**IN THE MATTER of Drury Metropolitan Centre Consolidated Stages
1 and 2 (the Project)**

JOINT WITNESS STATEMENT (JWS) IN RELATION TO:

Topic: Transportation

Date 3 October 2025

Figure 1: Difference in PM Flows when SH1DC is added (green=increase; blue=decrease)

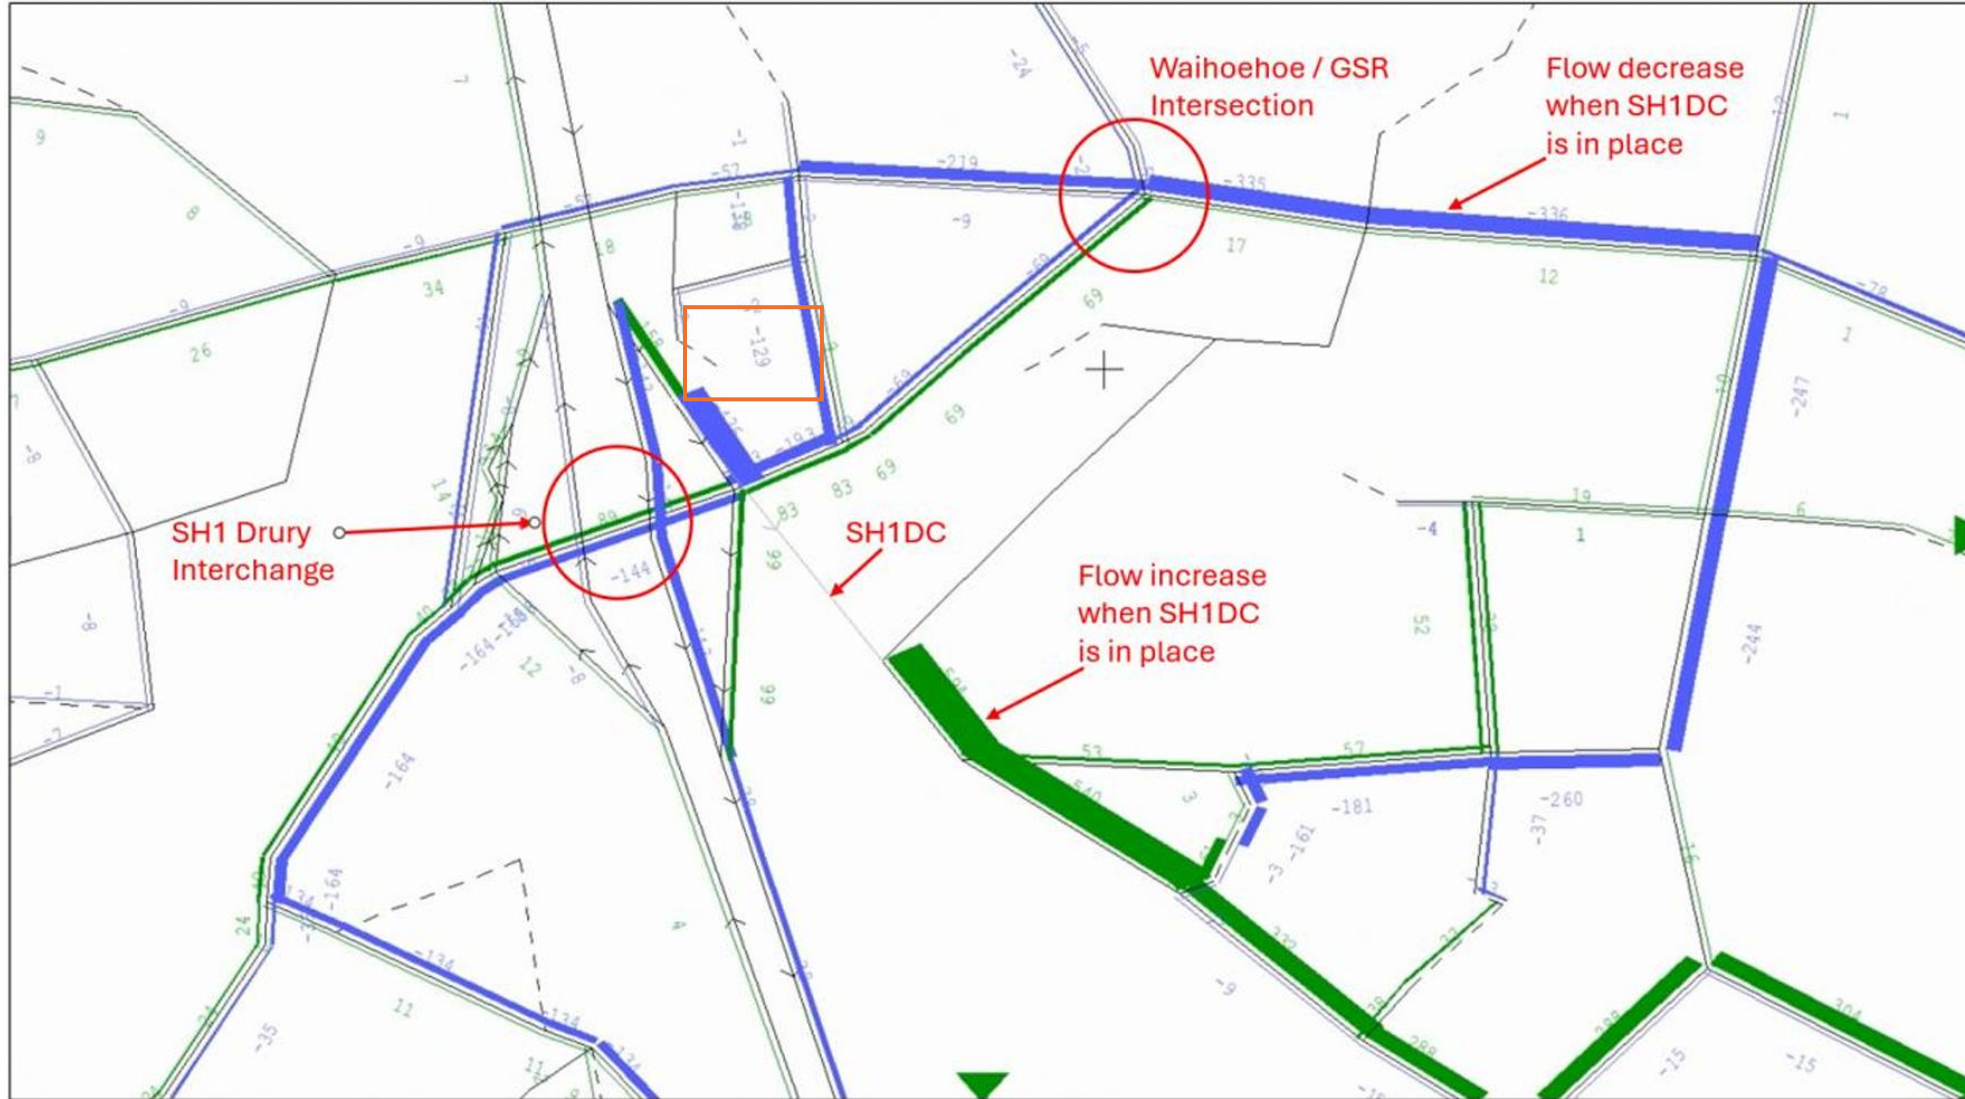
- a. *The SATURN modelling in the 26 August 2025 response (page 12) appears to show a new road connecting Bremner Road to Waihoehoe Road (essentially replacing Norrie Road which has an existing one-lane bridge). This route is being used as an alternative traffic route should the SH1DC link not be included. Please comment on the appropriateness of this road being included (as while it has been designated, it is not understood to be funded).*
- b. *Should this road not be constructed (and the Norrie Road one-lane bridge be retained), can please assess / provide traffic volume diagrams as to where this traffic would be deviated to, given the one-lane bridge constraint (e.g., would it be to Great South Road).*

- 3.3.1 DH confirmed his previous responses that Norrie Road upgrade appears to have been included in the SGA model that was adopted by the Plan Change Modelling. Sensitivity testing via manual reassignment has resulted in negligible effects in terms of assessing the delay of the Direct Connection ('SH1DC'). JP and LH support this response.
- 3.3.2 DH and JP note that the sensitivity analysis shows what will happen prior to the bridge being upgraded (refer to Agenda Item 2b above).
- 3.3.3 PS considers that while manual reassignment is an appropriate method, the updated sensitivity model may not reflect the real situation because it still has more traffic crossing the Norrie Road one-lane bridge than the bridge has capacity for.

Agenda Item A.2(d): SH1DC Delay – Design Differences

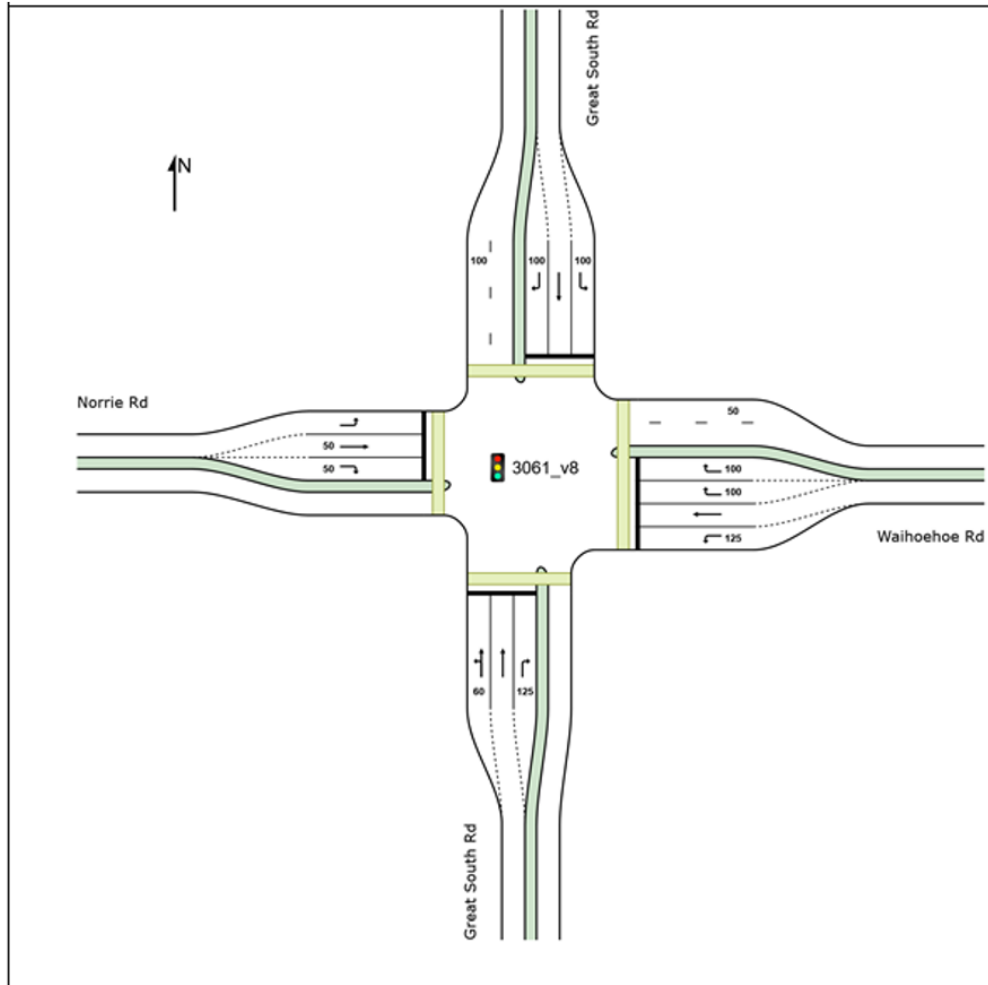
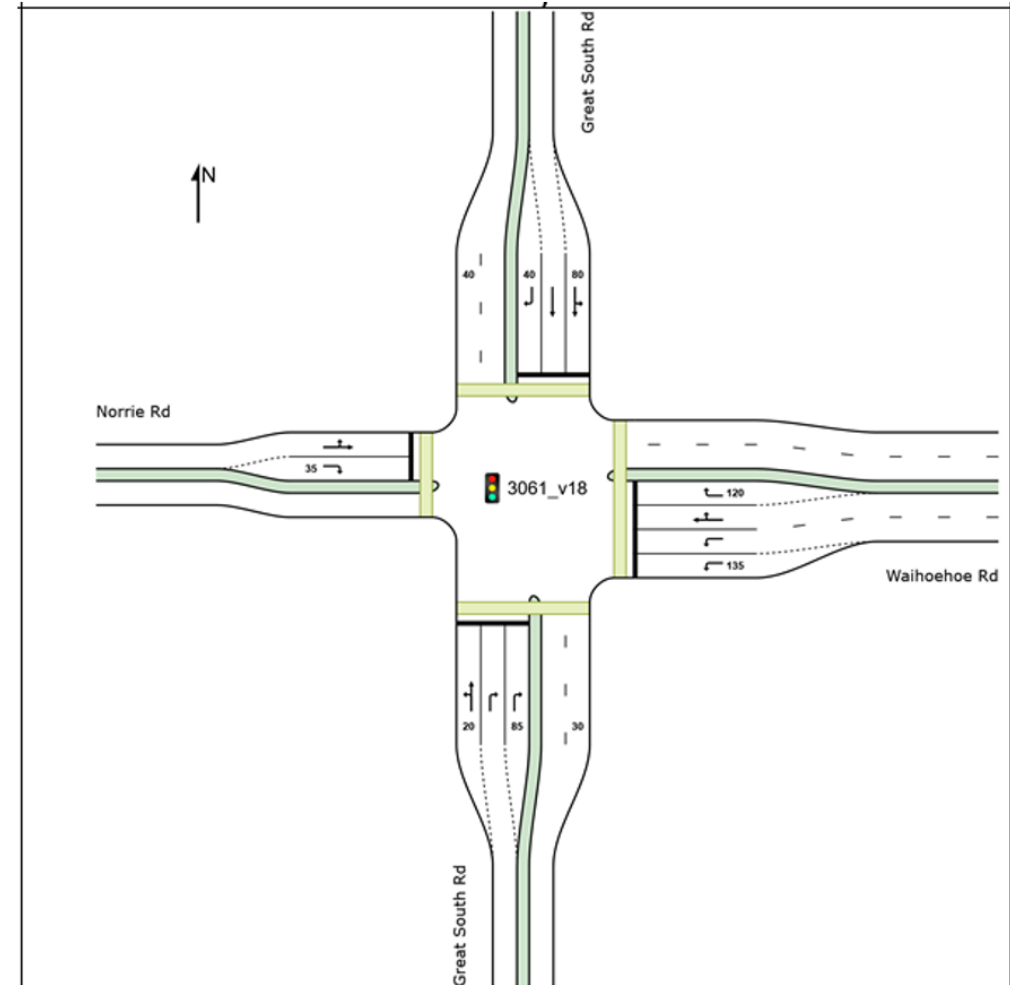
- 3.1.1 All transport experts agree that there is a new design for the Waihoehoe Road / Great South Road (GSR) intersection being designed by AT / NZTA. This intersection is less efficient than that used in Council's transport model for the purpose of Plan Change 48 and the Waihoehoe Road / GSR roading designations.

- 3.1.4 PS and CF consider that for purposes of assessing the change in the threshold for the direct connection, the assessment should be done on the basis of the intersection as it is currently being designed and not that in the Plan Change. The AT / NZTA design is 85% complete and understand that it is going out to tender soon and therefore consider that it is unlikely that it will be changed back to the Plan Change design.

- 3.1.6 The proposed solution is to introduce a new condition requiring the NZTA/AT intersection (assuming it is built based on the current design) to be upgraded to include additional and longer approach lanes in accordance with the attached diagram (Attachment A – pp. 35 - 36) after the threshold of 2,700vph has been met. This will allow the full development up to 3,800vph.

Testing of GSR / Waihoehoe intersection showing low equivalent interpeak delays / queues

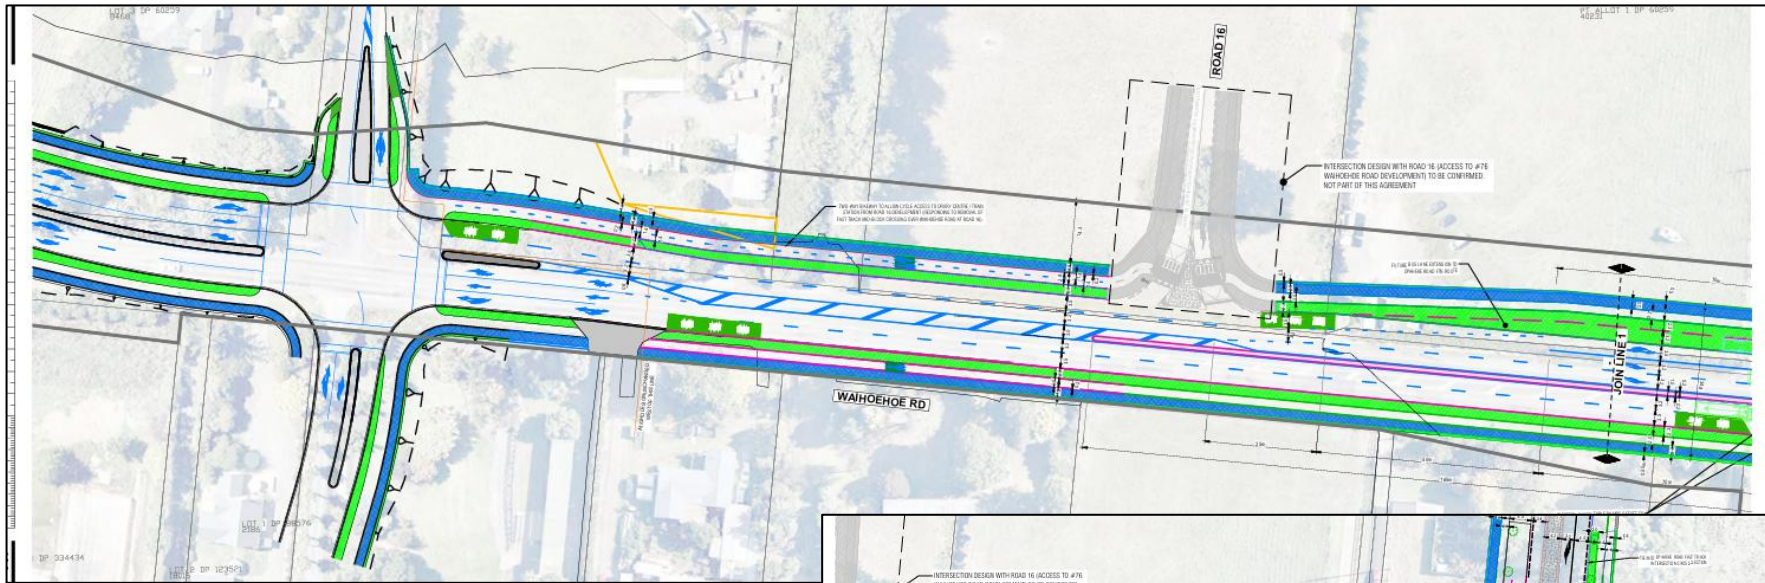
3. Issue: Inter-peak and public transport delay concerns.

- 3.10.1 DH has provided additional information to address this issue (Attachment A – p. 30). LH confirms no further information is required.

Agenda Item B: Items Marked Satisfied – Weekend Testing

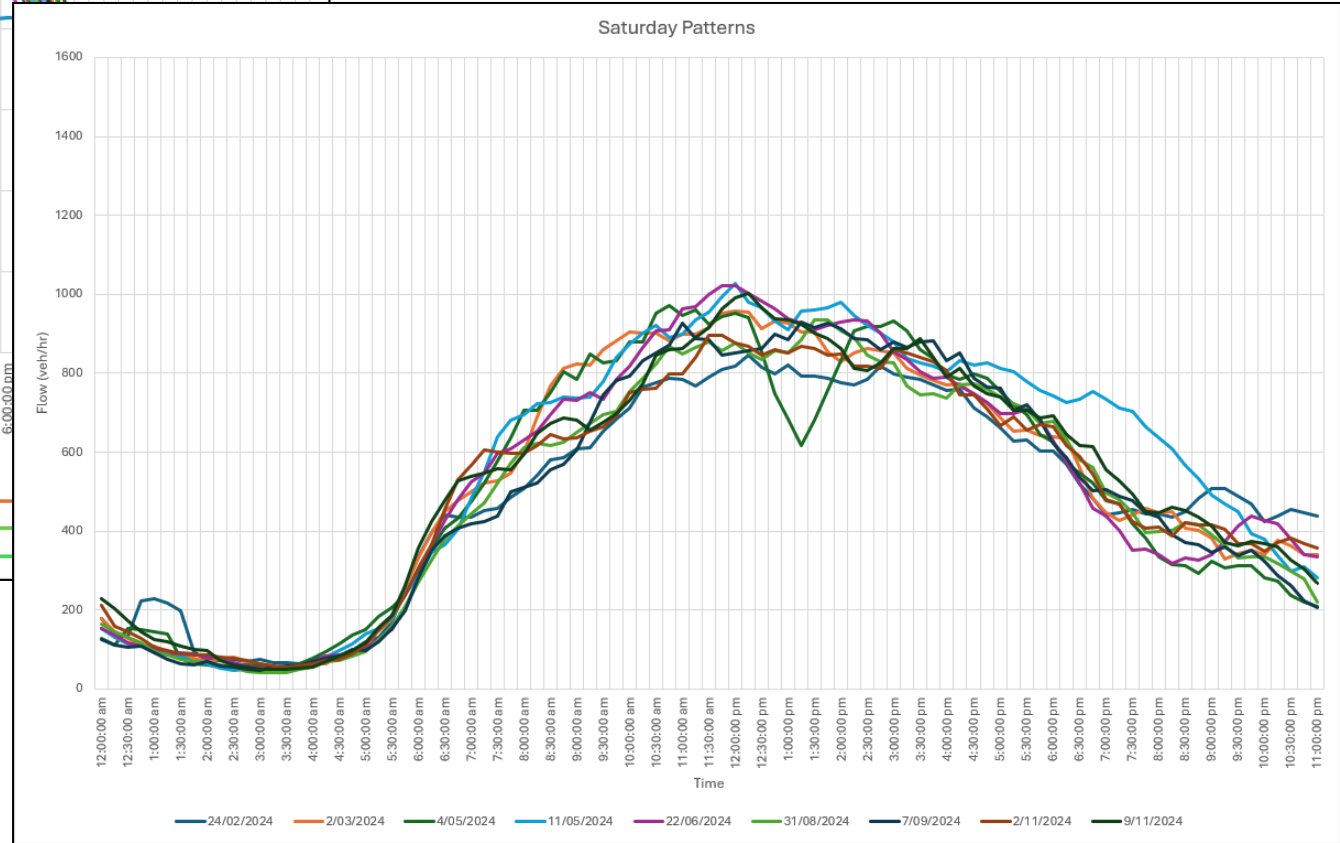
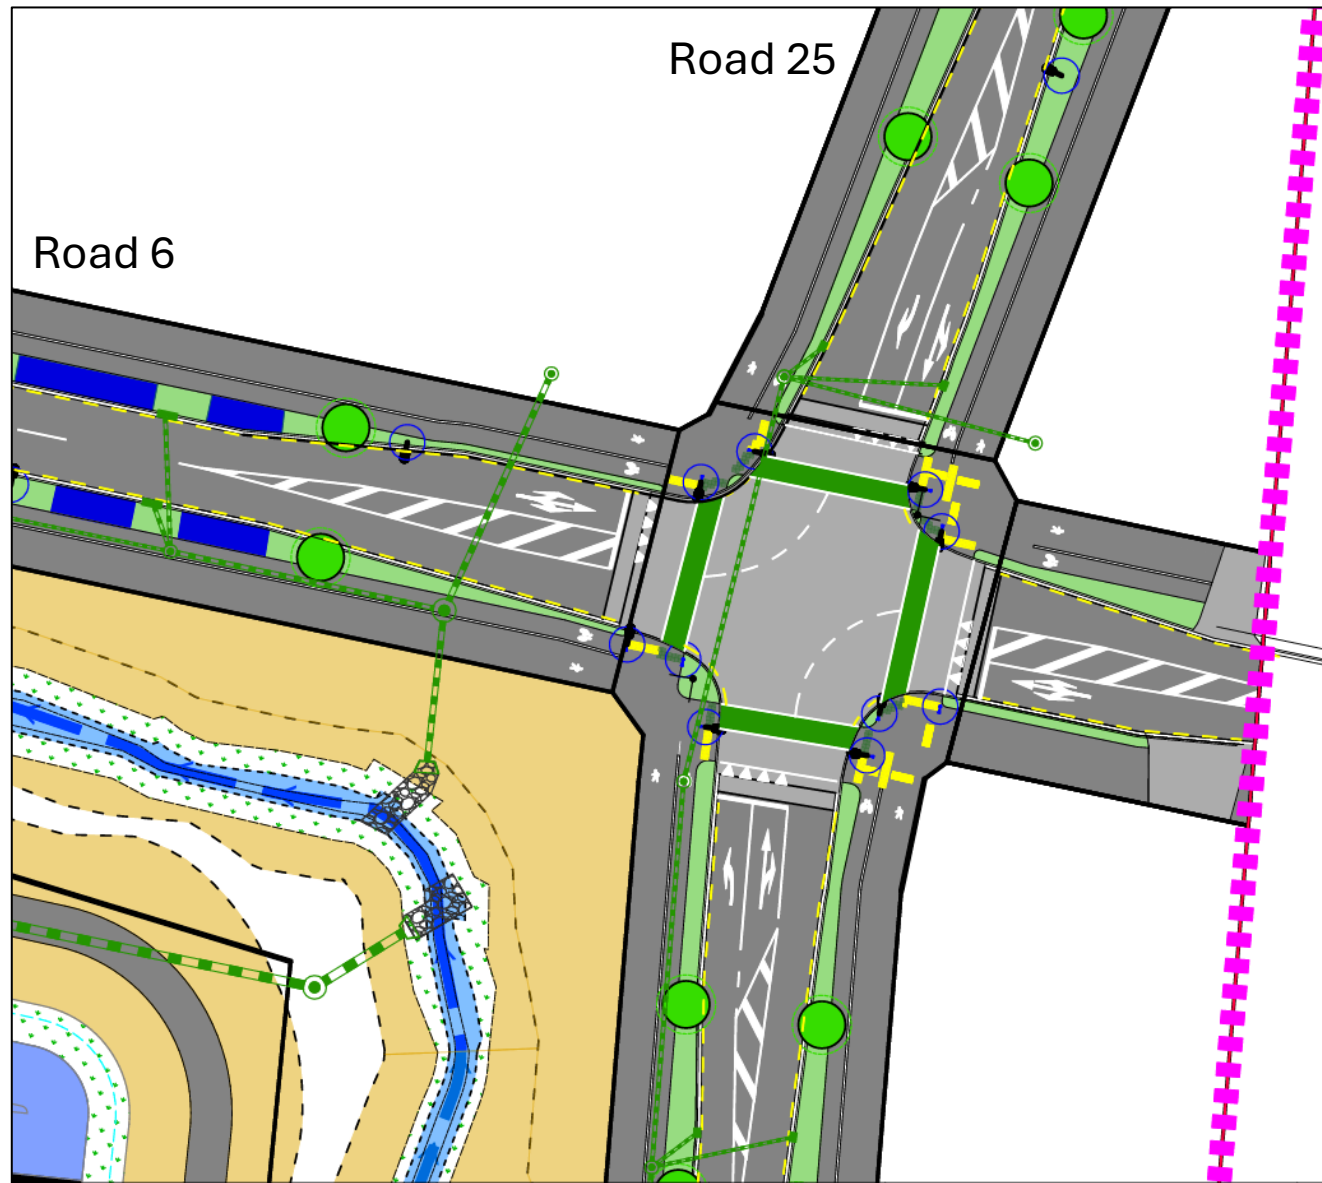
4. Issue: Weekend testing.

- 3.11.2 PS considers that because most trip generation from the applicant’s site is generated from the retail activity, that it is highly likely that there will be significant congestion in the Saturday interpeak but this has not been assessed in detail by the applicant’s traffic engineer. PS notes that while shopping trips to the retail development are discretionary, not all trips passing through the area are discretionary. Residents travelling to and from their homes will be affected by the congestion generated by the proposed development, as will existing users of GSR and the public transport feeder service to the station using GSR.

- 3.11.3 PT considers that as the nature of the development is retail-led, which means that the weekends can be congested, especially Saturday, which could trigger the threshold earlier than expected. This means that the applicant needs to get some weekend testing done and there is a significant gap in the information provided.

- 3.11.1 DH advised that there is limited information available, but what he has identified shows that there is a shallower and reduced Saturday peak in comparison to a PM weekday peak at the SH1 southbound offramp. LH considers that this demonstrates it is unlikely that the Saturday peak is critical in this location. No further discussion is required. DH and JP agree and note that the shopping trip is a discretionary trip that people can take at times when there is less congestion if they wish.

Agenda Item B: Items Marked Satisfied – Vehicle Crossing Rd 6 / Rd 25

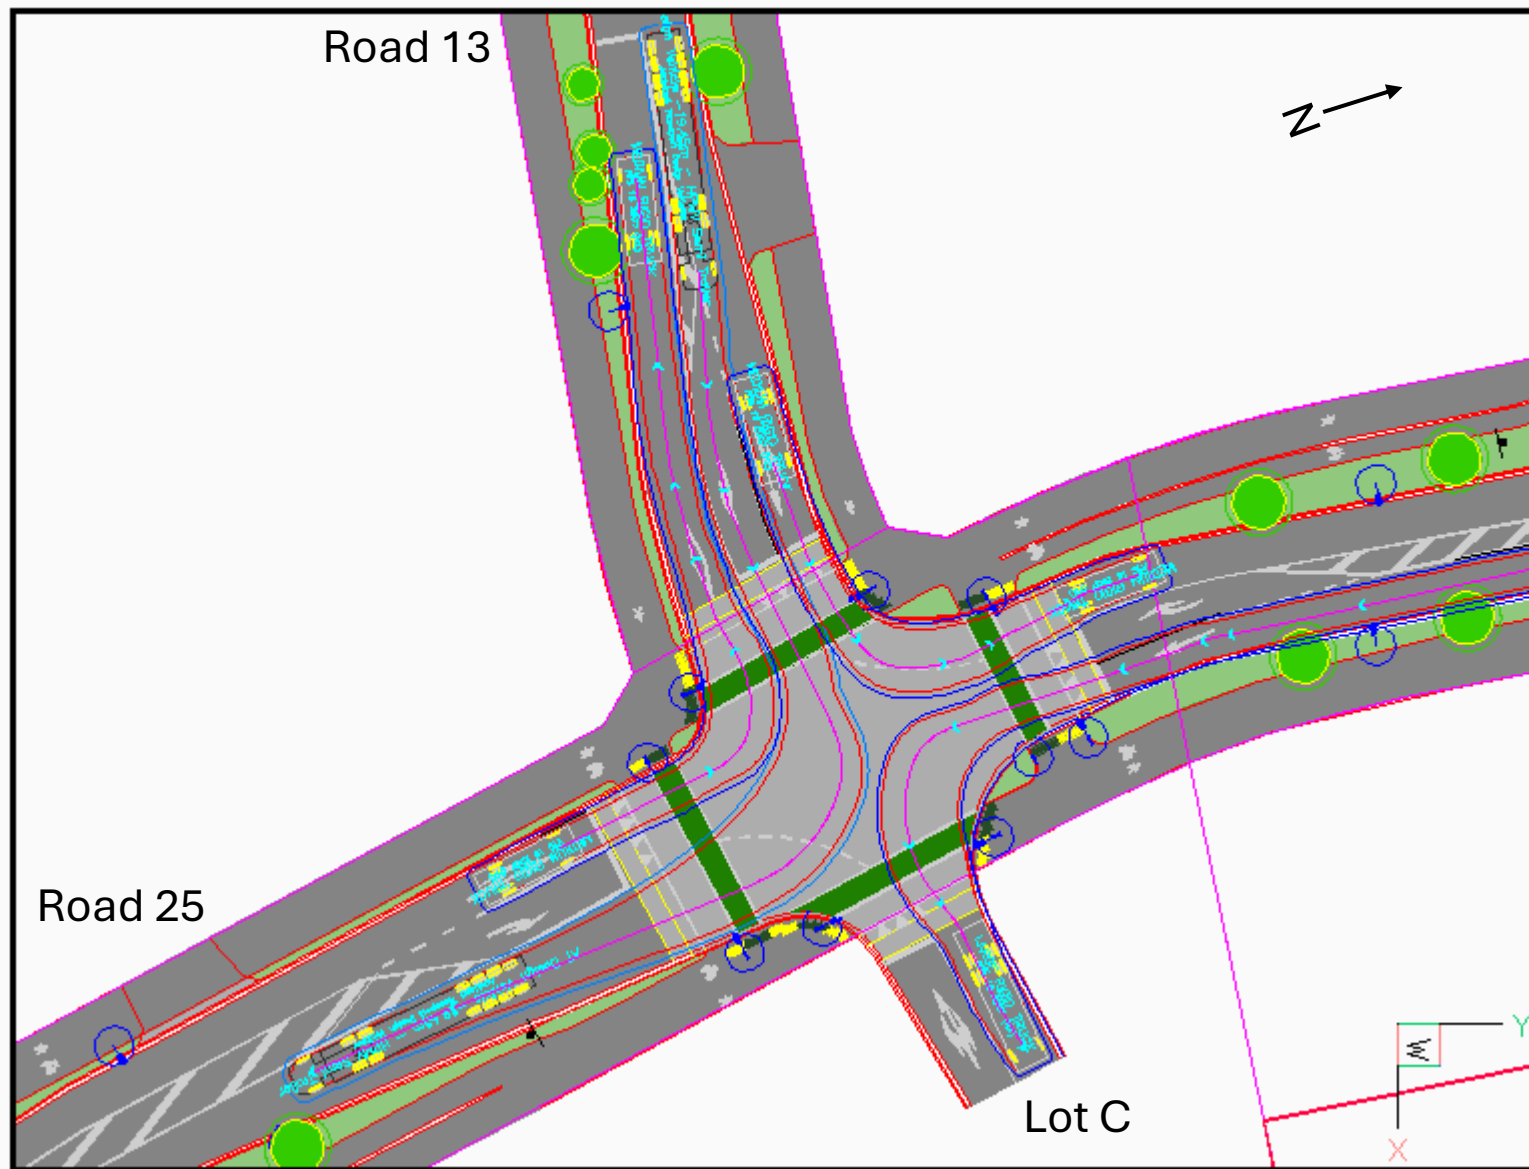
6. Issue: Vehicle crossings and the fourth-leg connection at the Road 6 / Road 25 signalised intersection.

- 3.13.1 MC considers this is generally addressed based on the provided documentation (Woods) but notes that the mountable kerb proposed for the wide vehicle crossings should be reduced to provide for mountable kerbs only where the trucks track across and not in the area needed for light vehicle tracking.
- 3.13.2 NR and MW will confirm if this can be incorporated into an existing proposed condition with the design being finalised as part of the EPA.
- 3.13.3 MF, CF, and MC consider the Road 6 stub should be vested as a public road as it is shown as a collector road on the Precinct plan and will need to be extended through adjacent private land in future.
- 3.13.4 DH disagrees with para 3.13.3 and believes that the future extension can be dealt with whilst retaining private ownership of the stub road.
